Subject: Dresden Station Unit 3 - Supplement C to  
 Second Reload License Submittal and Proposed  
 Change to Facility Operating License DPR-25,  
 AEC Dkt 50-249

Supplement C to Second Reload License Submittal

## ANALYSIS OF FUEL DENSIFICATION EFFECTS

FIGURE 3.5.1 MAXIMUM ALLOWABLE PLANAR LHGR

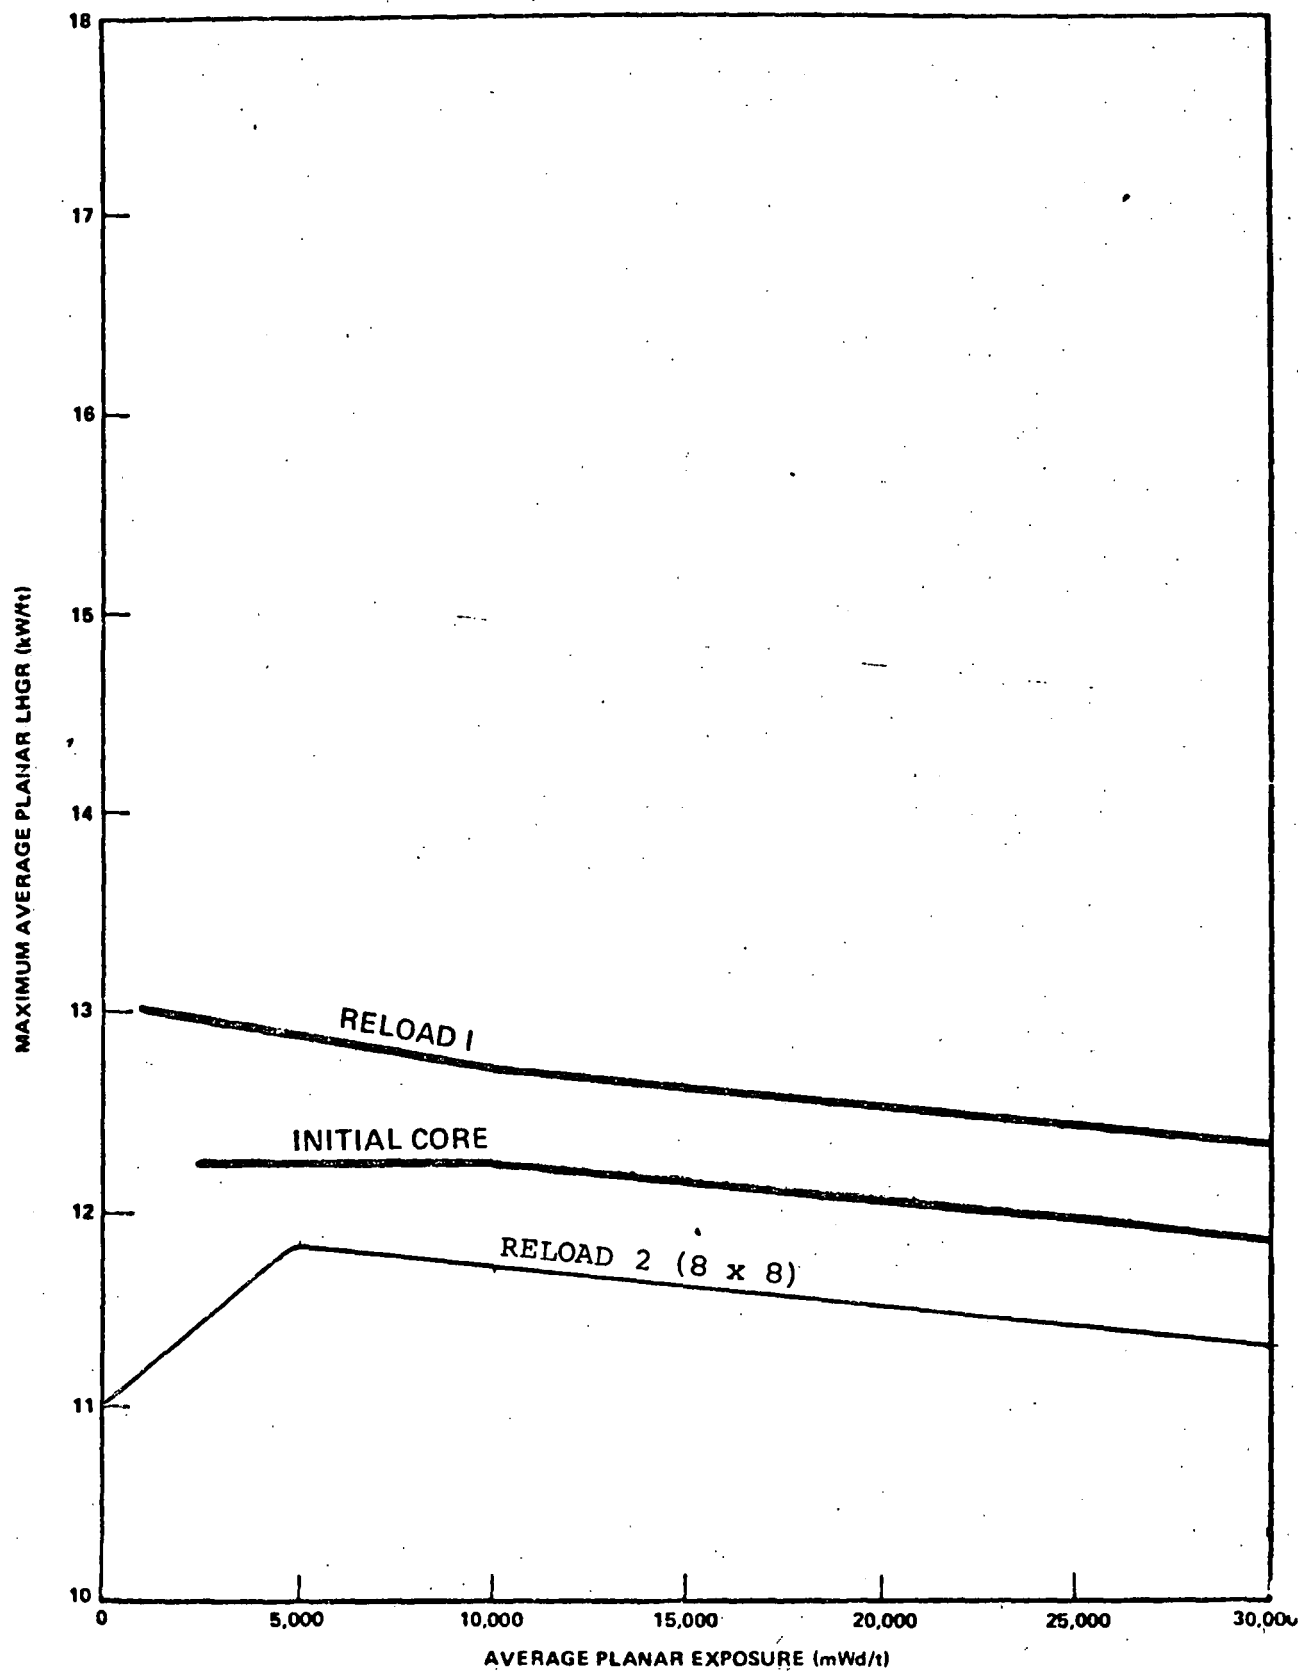
During steady state power operation, the average linear heat generation rate (LHGR) of all the rods in any fuel assembly, as a function of average planar exposure, at any axial location, shall not exceed the maximum average planar LHGR shown in Figure 3.5.1.

The maximum average planar LHGR shown in Figure 3.5.1 for 7 x 7 lattice fuel is the same as that shown on the curve labeled " $\gamma$ " (gamma) on Figures 4-9J1 and 4-9J2 of the GE topical report "Fuel Densification Effects on General Electric Boiling Water Reactor Fuel," NEDM-10735, Supplement 6, August 1973 and is the result of the calculations presented in Section 4.3.4 of the same report. These calculations were made to determine the effect of densification on peak clad temperature and were performed in accordance with the AEC Fuel Densification Model for BWR's which is attached to NEDM-10735, Supplement 6 as Appendix B. The maximum planar LHGR in Figure 3.5.1 for 8 x 8 lattice fuel is the same as that

shown on the curve labeled " $\gamma$ " (gamma) on Figure 7 of "Dresden Unit 3 Supplement C to Second Reload License Submittal", dated December 4, 1973.
